STATE OF HAWAII DEPARTMENT OF TRANSPORTATION HIGHWAYS DIVISION	
INDEX TO DRAWINGS	
RAMP-IF	
STA: 78+17.13 TO STA: 85+37.69	
AIRPORT INTERCHANGE	
F.A.I. PROJECT No. I-HI-1 (174)16	
SCALE: N.T.S.	DATE: SEPT. 1982
SHEET No. I-1 OF 42 SHEETS

Contract Change Order No. 2 - Footing 30F Revision

STATE OF HAWAII DEPARTMENT OF TRANSPORTATION HIGHWAYS DIVISION	
REVISED FOOTING 30F DETAIL	
RAMP IF	
AIRPORT INTERCHANGE E.A.I. PROJ. NO. I-HI-1 (174) 16	
SCALE: AS SHOWN	DATE: JULY, 1983
SHEET NO. 8A OF SHEETS

14

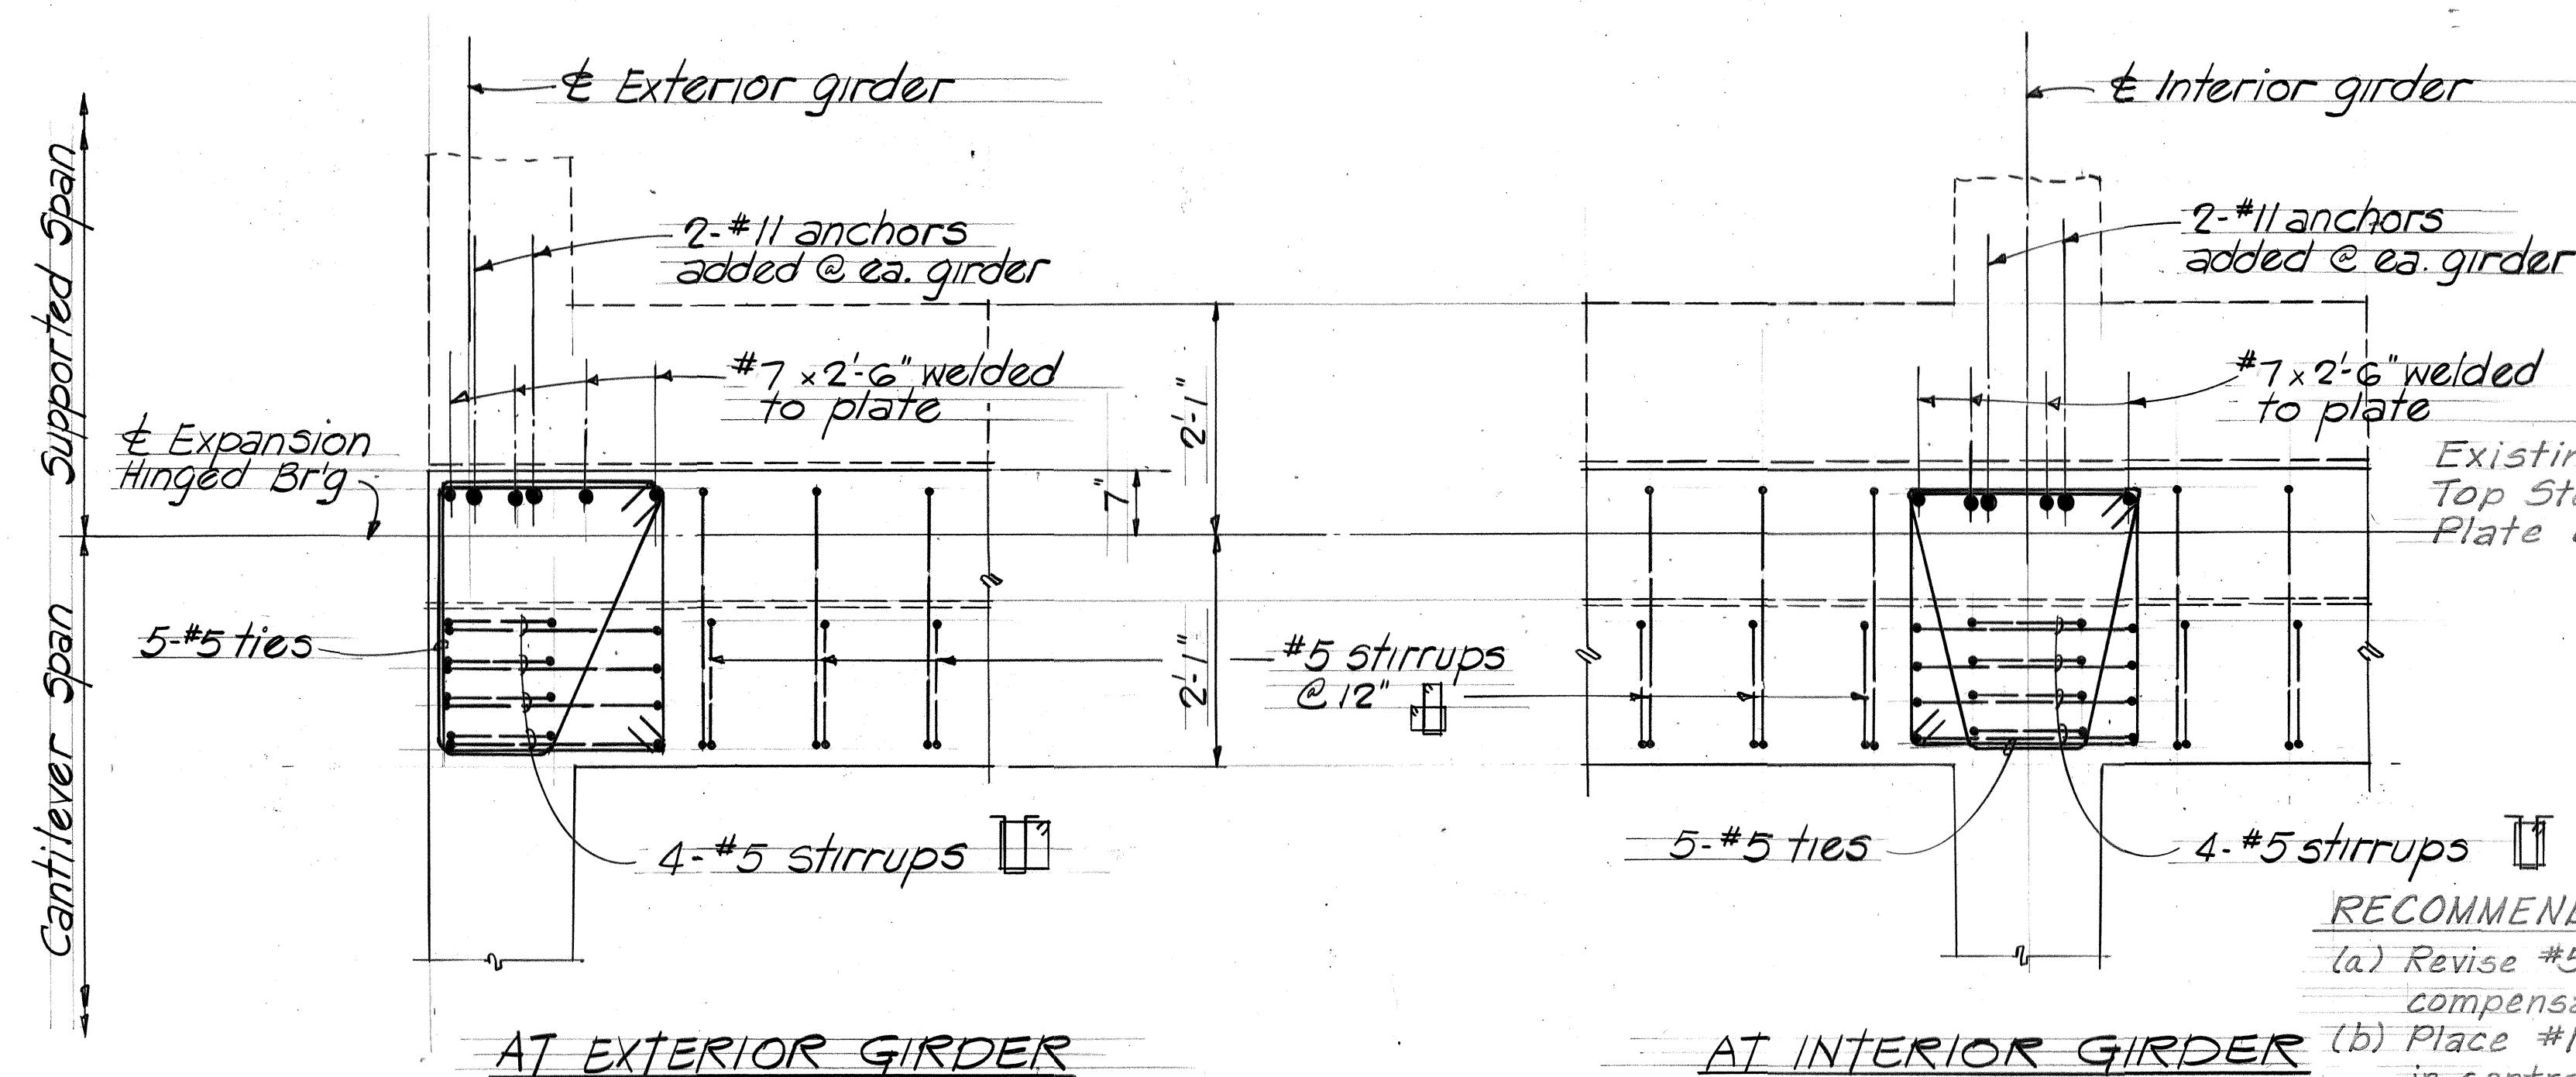
RECOMMENDED REVISIONS:

CONTRACT CHANGE ORDER NO. 5

- Revise #5 stirrups (fabricate longer) to compensate for deeper webs.
- Place #11 using original cover as shown in contract plans at bottom slab and vertical face. Let top slab take up the balance.
